HTE# 12-5-3002812

Harnett County Department of Public Health Site Sketch

ISSUED TO: RODMOND BOYCE PROPERTY LOCATION: SR 1727 SUGGERS RD
SUBDIVISION: WATTS CROSSING LOT # 11

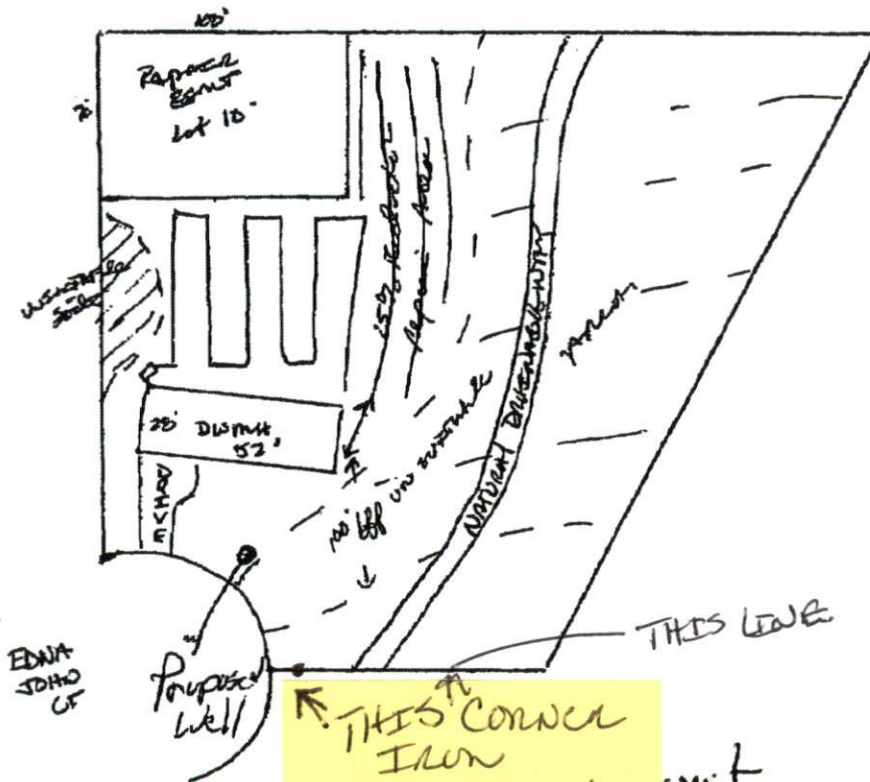
11-27-12 MET Septic Contractor on site for layout

Site → Flagged and discussed layout - Told to start at 22" max

Stepdowns will be required. BUT TO USE 2 1/2" Fall in 100' ^{rule}

Bottom of Stepdown should NOT be higher than

Bottom of outlet or TANK.

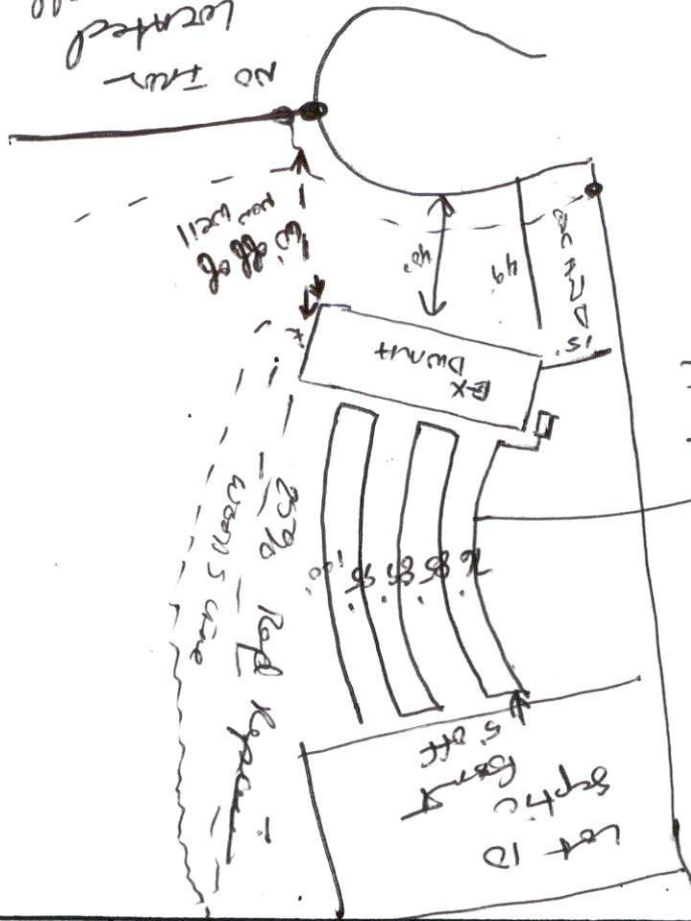
- * Contractor to meet ON SITE prior to INSTALL
- * WATER AND POWER CANNOT BE IN system OR Repair Area.
- * THIS Permit IS FOR Site only, NOT NEW WELL OR SYSTEM

THIS CORNER IRON
and property line to
be 100'
off site
